East Broad Market Lofts PUD 20180426 Approved Master Plan and PUD Changes

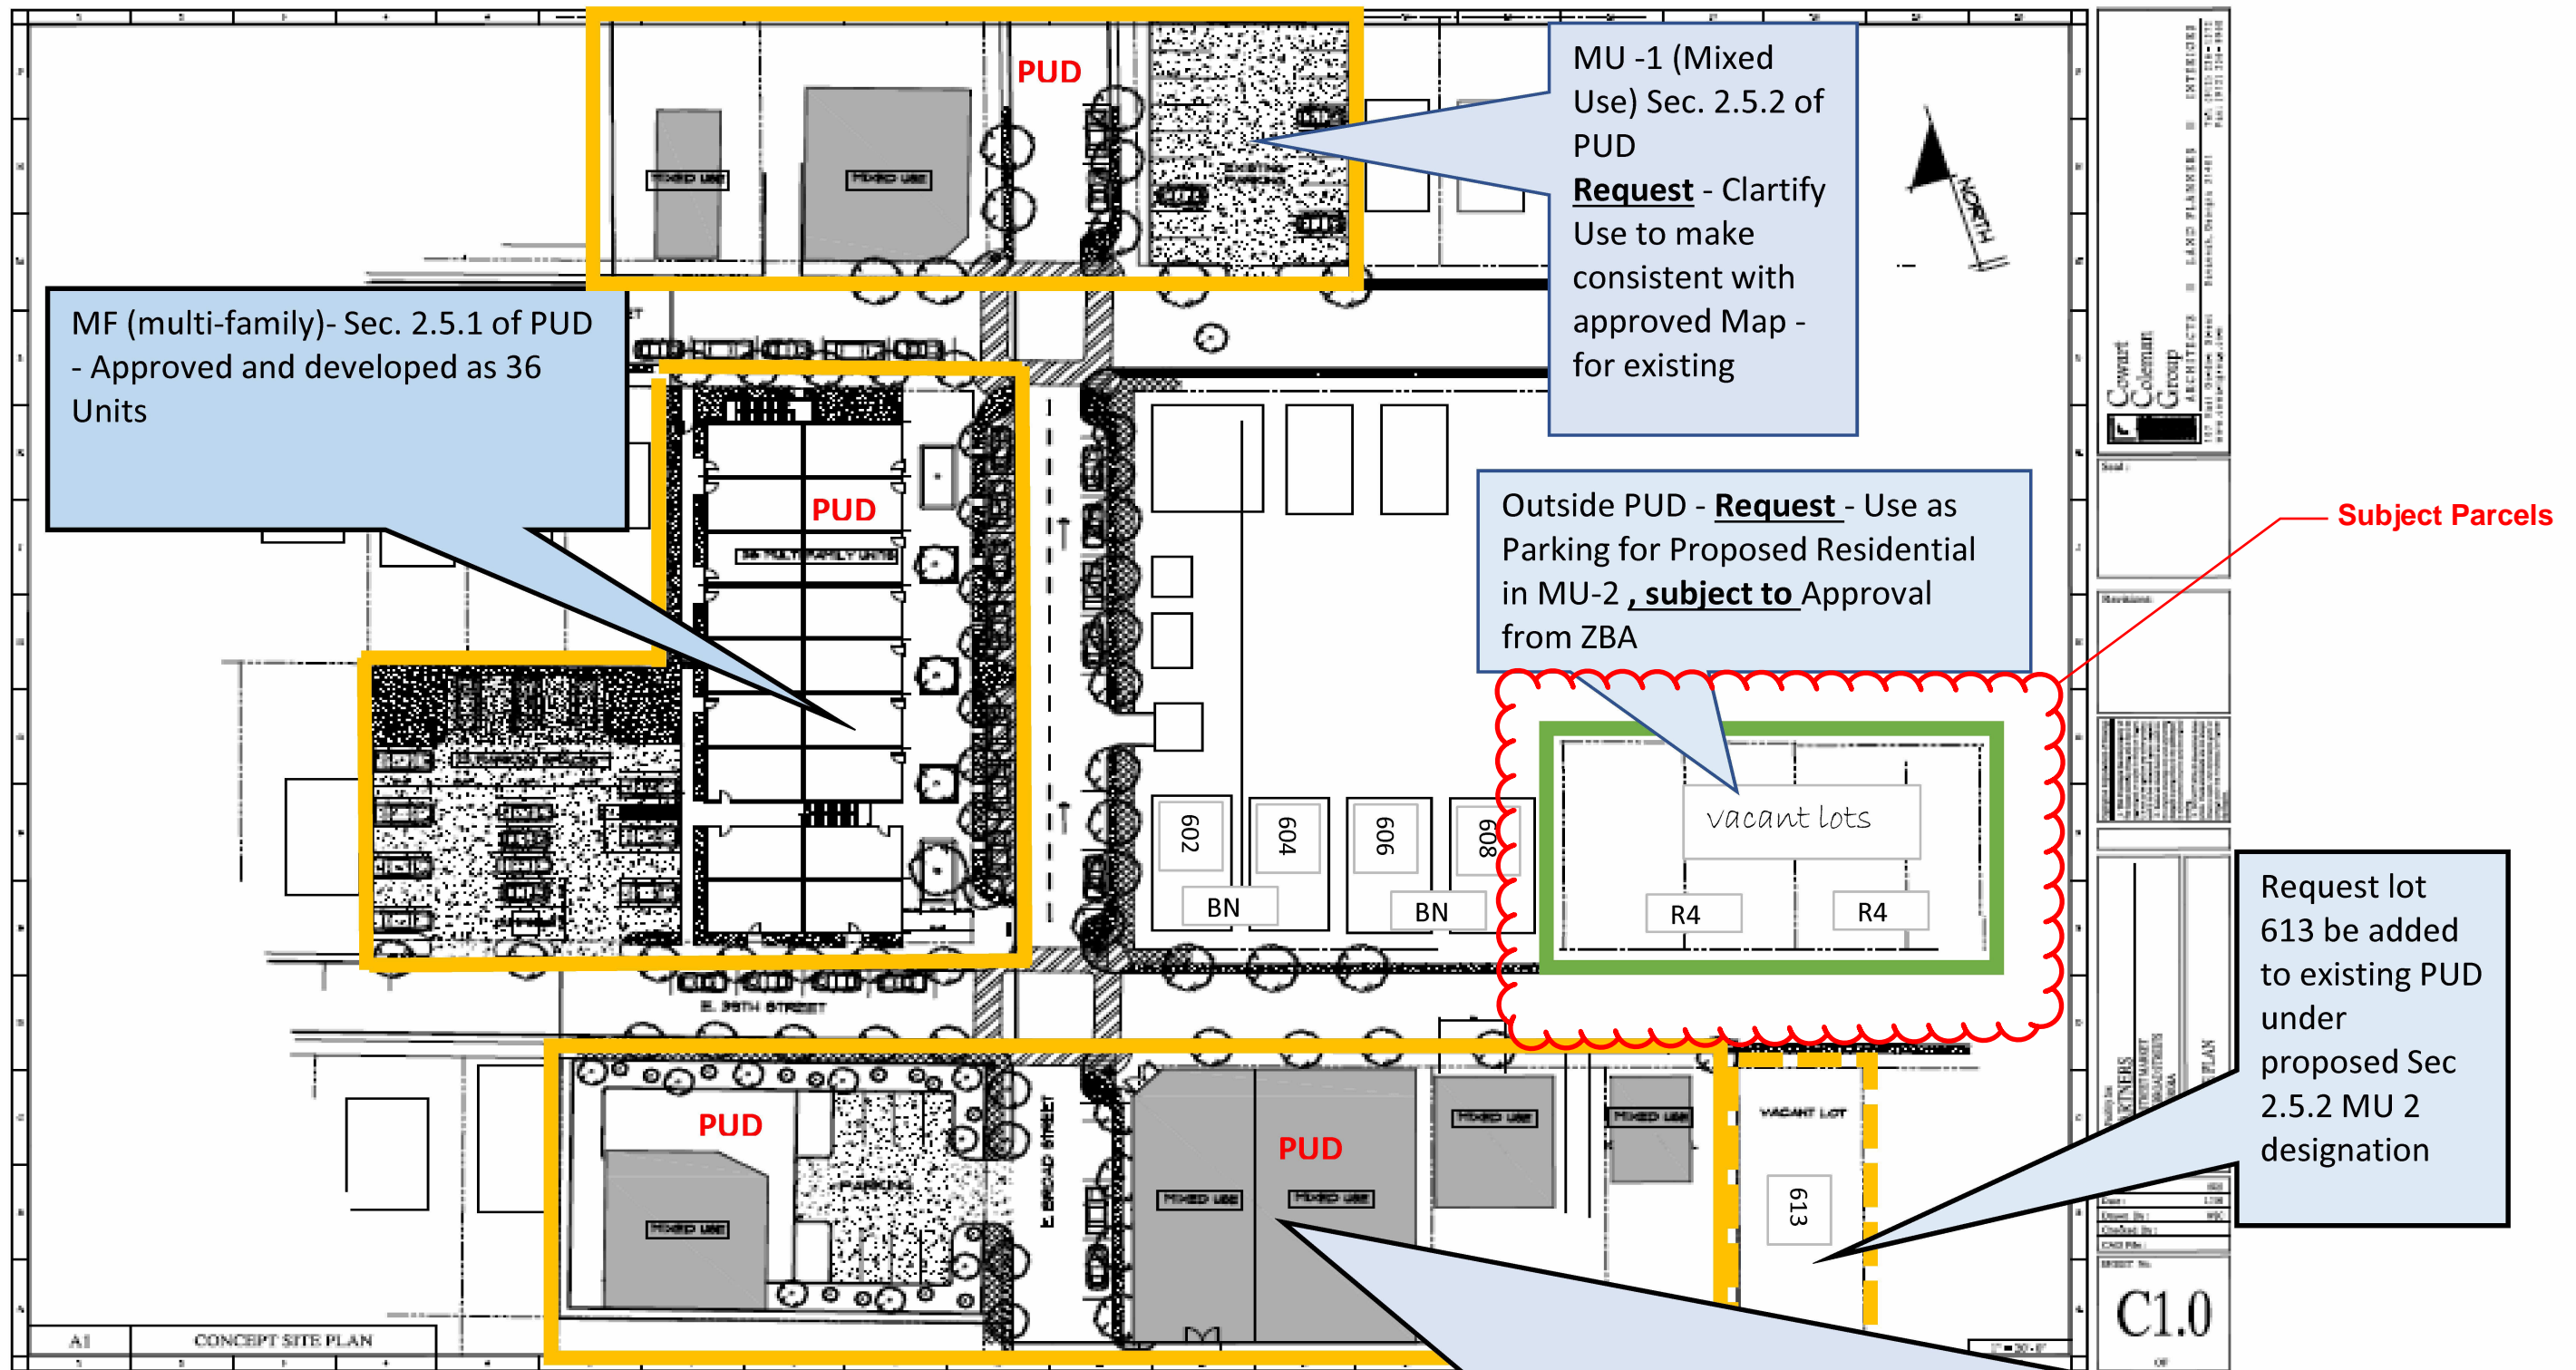
MU -1 (Mixed Use) Sec. 2.5.2 of PUD
Request - Clarify Use to make consistent with approved Map - for existing

Outside PUD - **Request** - Use as Parking for Proposed Residential in MU-2 , **subject to** Approval from ZBA

Request lot 613 be added to existing PUD under proposed Sec 2.5.2 MU 2 designation

MU -2 (Mixed Use) Sec. 2.5.2 of PUD **Request** -

1. Alter MU-2 for same density as MF 2.5.1 (36 units)
2. Allow ground floor residence same as MF 2.5.1
3. Substitute the parking requirements with those same parking provisions contained in Sec. 8-3224 Parking - Mid-City Zoning Ordinance

SUBJECT TO - Plan Site Review and Approval showing proposed parking (including design and landscaping of proposed parking lot) AND Review and Approval of the facade design (including building material) ; building layouts and location (no building to exceed 5k sf footprint as recommended by MPC); hardscape and landscaping.
